**AGENDA ITEM: 1a****HPO File No. 070601****SITE NAME:** Palace Hotel**SITE LOCATION:** 216 LaBranch Street (aka 1417-1419 Congress Avenue)**Owner:** 1417 Congress Partners, LTD.**Applicant:** Accent Signs

On July 17, 2003 the HAHC granted the owner of the building a Certificate of Appropriateness to restore the facades of the building and construct a metal balcony. The applicant requests approval of a certificate of appropriateness for the following work:

**CERTIFICATE OF APPROPRIATNESS**

Proposed Alteration - (Sign)  
Not to Scale

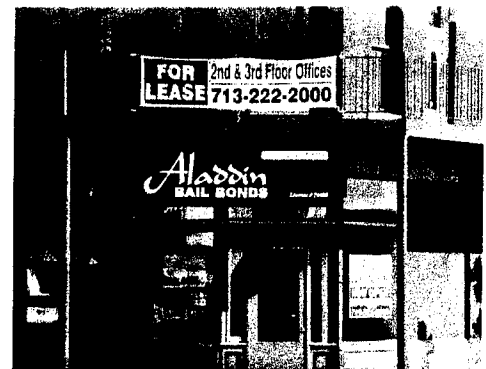
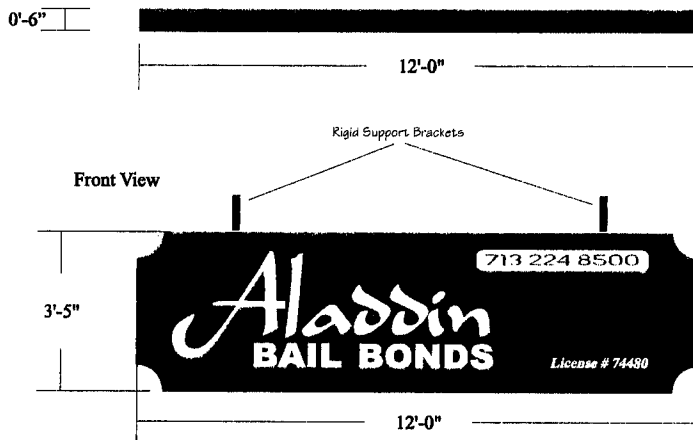
**STAFF RECOMMENDATION:** Approval of the certificate of appropriateness as requested by the applicant.
